GEOSHIELD Verification Report

PROJECT REFERENCE: GEO102491

REPORT NUMBER: 001

PROJECT: Blocks D3 & D4. Clarendon Road.

Fault 1 of 2 identified.

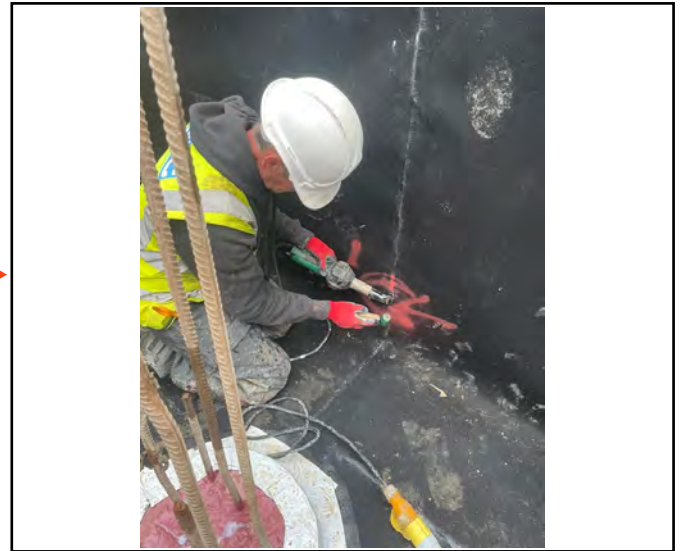
During the visual inspection and thorough pick and probe testing conducted throughout the Pudlo ultra plus installation to the core area a couple of faults were identified. These areas were highlighted so the installers could carry out the necessary remediations.

The photograph on the left shows one of the faults identified (miswelded lap joint)

and highlighted. The photograph on the right shows the NVQ qualified installer

from SWC carrying out the remediation re-welding the lap joint using a hot air tool

and silicone roller. No outstanding remediations.

Remediated on-site.

The installer re-welding the lap joint.

No outstanding remediations.
